**TOWN OF NEWBURGH  
PLANNING BOARD  
TECHNICAL REVIEW COMMENTS**

**PROJECT: GARDNER RIDGE**  
**PROJECT NO.: 2002-29**  
**PROJECT LOCATION: SECTION 75, BLOCK 1, LOT 4.12**  
**REVIEW DATE: 1 MARCH 2016**  
**MEETING DATE: 3 MARCH 2016**  
**PROJECT REPRESENTATIVE: TOM OLLEY AND DARREN DOCE, P.E.**

**STORMWATER MANAGEMENT BASIN  
OUTLET STRUCTURE**  
NOT TO SCALE

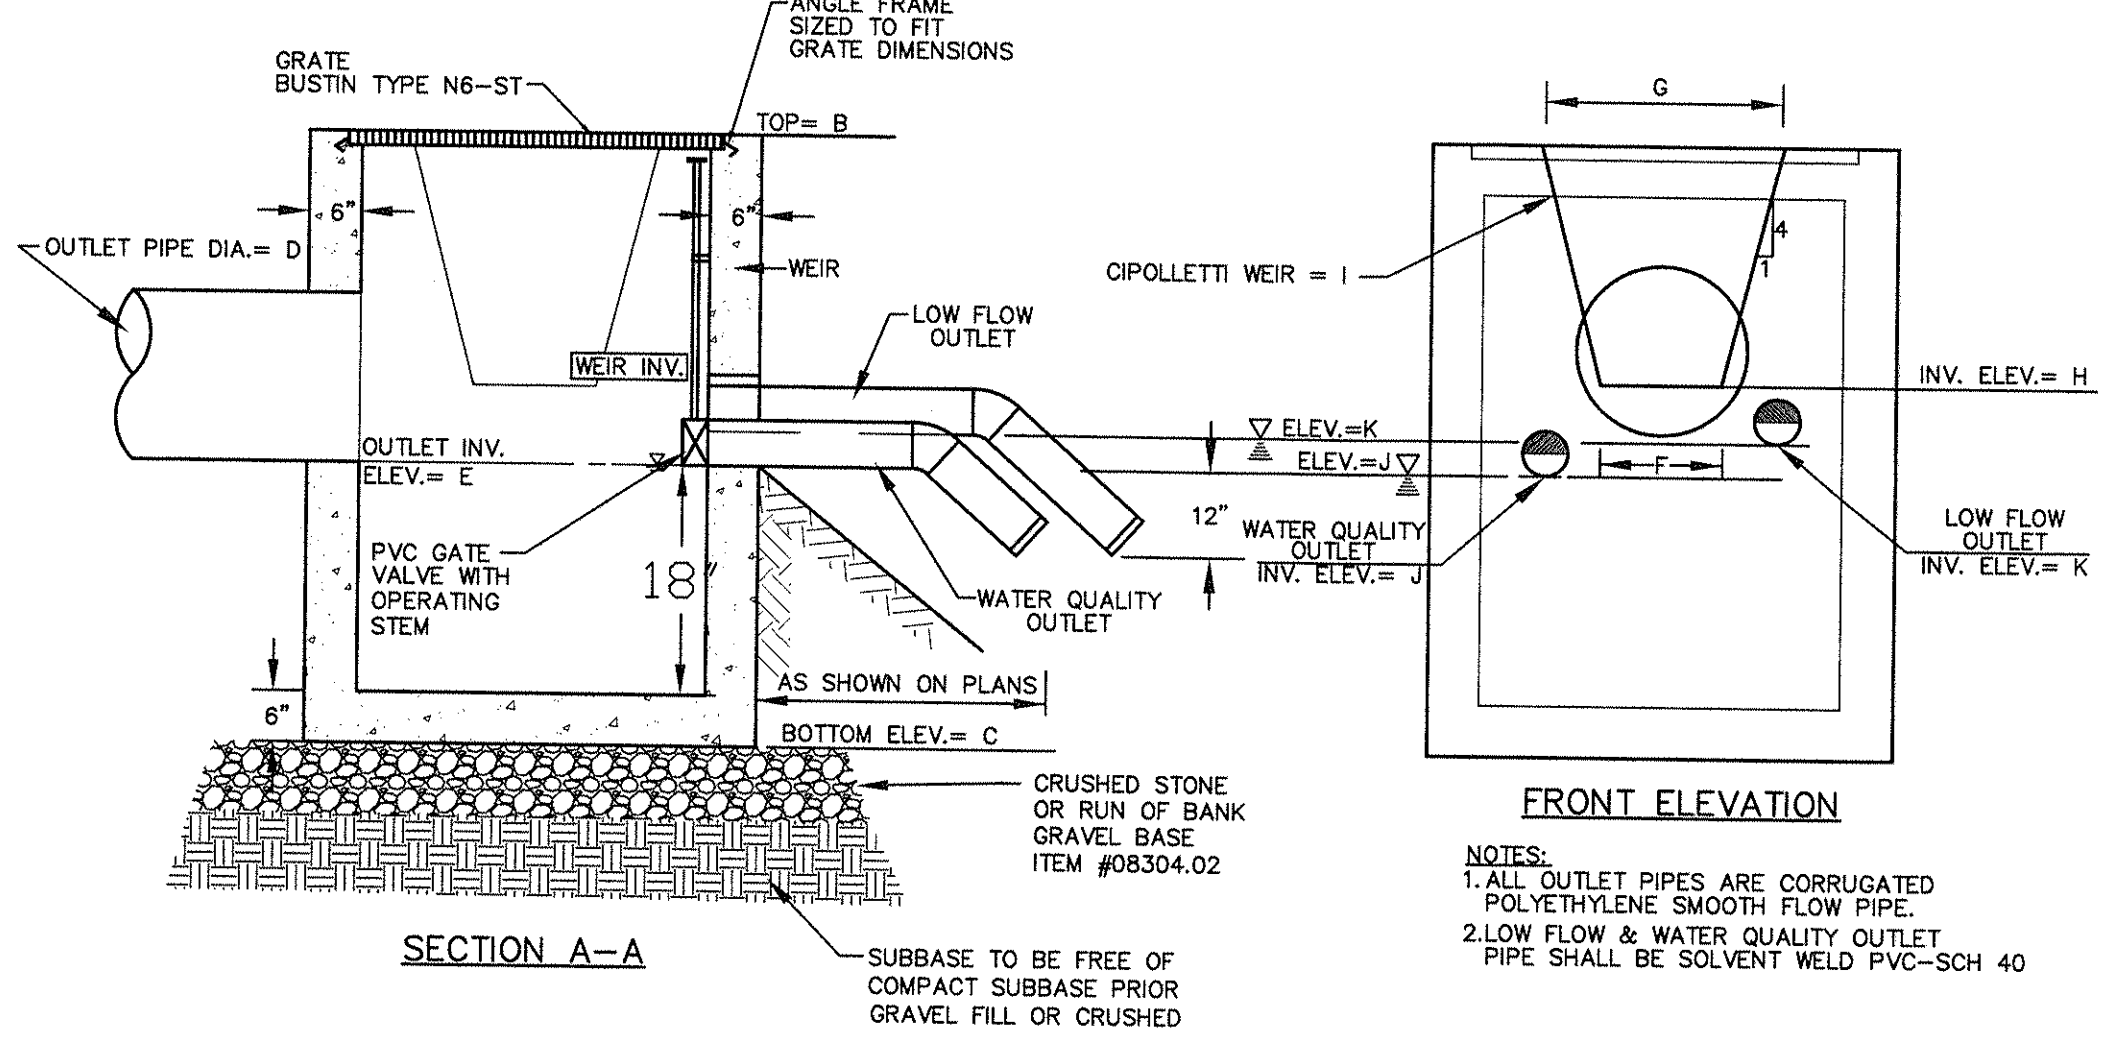
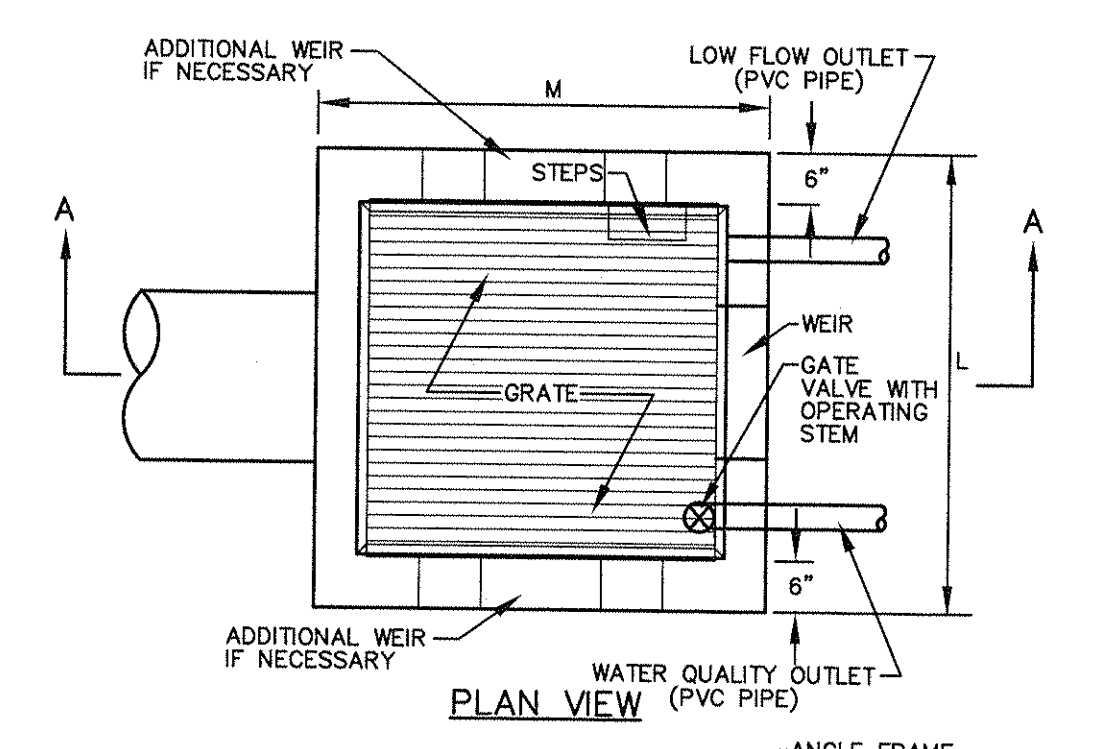
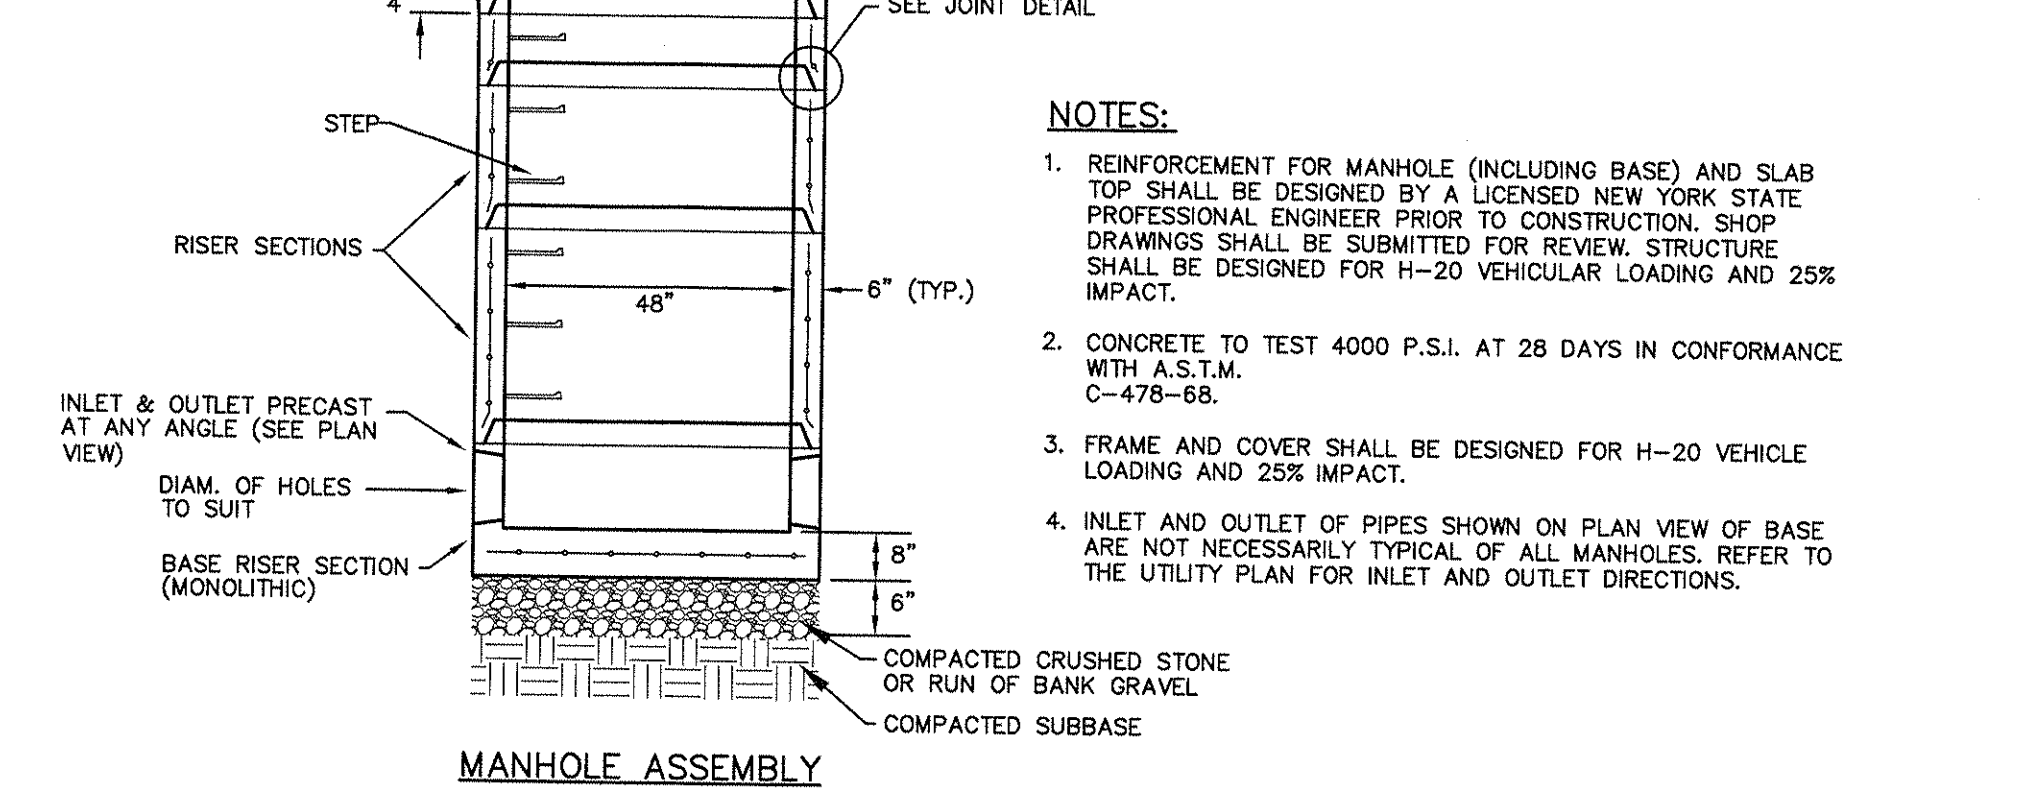
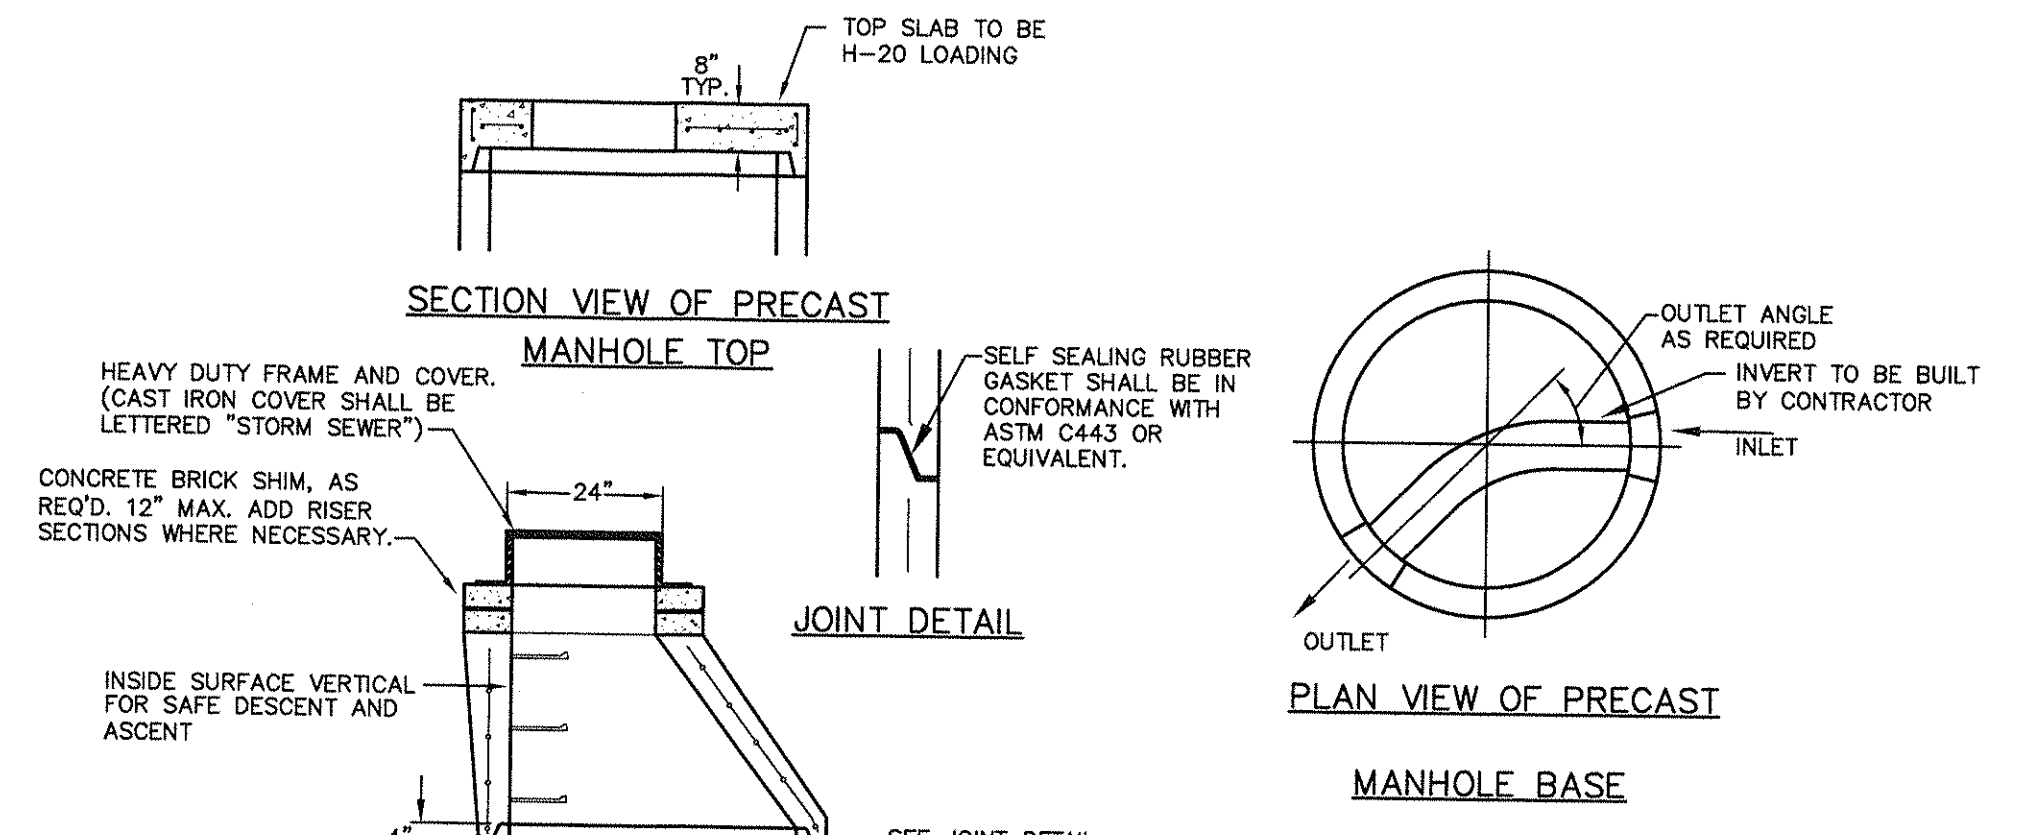
24. Details of the outlet control structure should be provided on the plans along with appropriate elevations.
